Accessibility Survey

City of Downey Vista Del Rosa Street & Paramount Boulevard

Date of Inspection
5/11/2017

Prepared By
Disability Access Consultants
(800) 743-7067

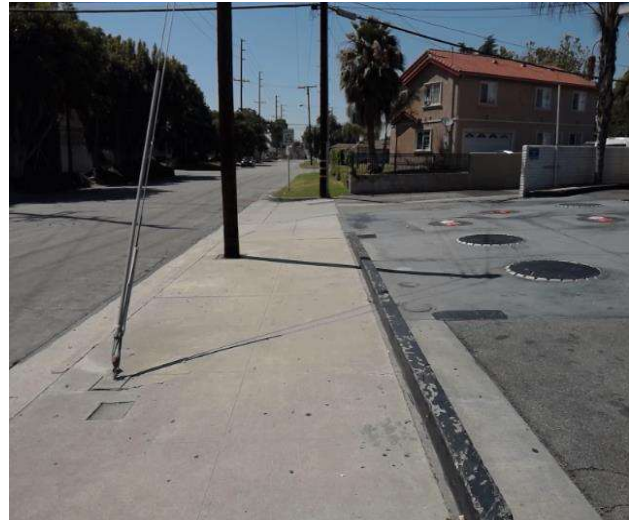
Sidewalk cross slope is not compliant.

On-Site Finding 2.70 percent for 32.00 feet

Repave the sidewalk surface with the recommended cross slope.

Change in Level East of Lowman Avenue @ 33.966422556921, -118.118214011192

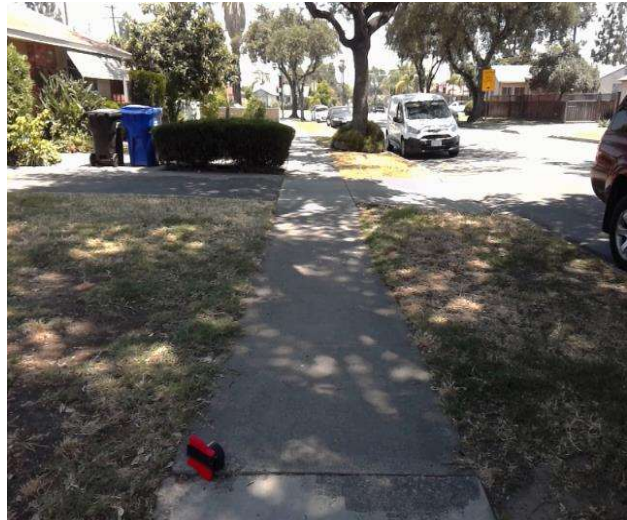
There is a change in elevation greater than recommended value.

On-Site Finding 0.50 inches

Ensure that the change in elevation is within the recommended value.

Change in Level East of Parrot Avenue @ 33.964253611883, -118.116095066071

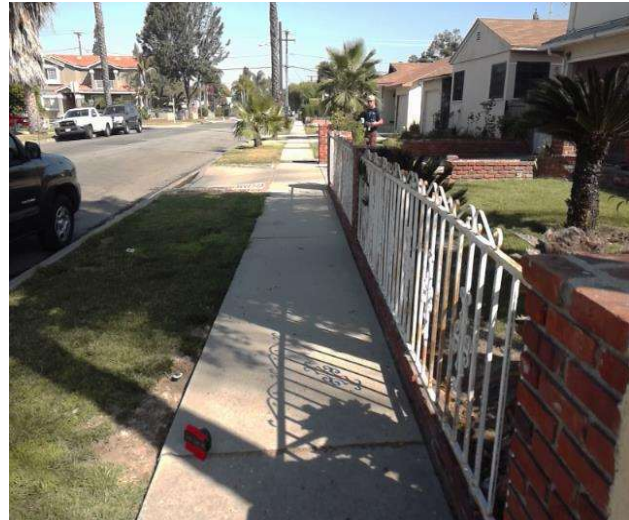
There is a change in elevation greater than recommended value.

On-Site Finding 0.37 inches

Ensure that the change in elevation is within the recommended value.
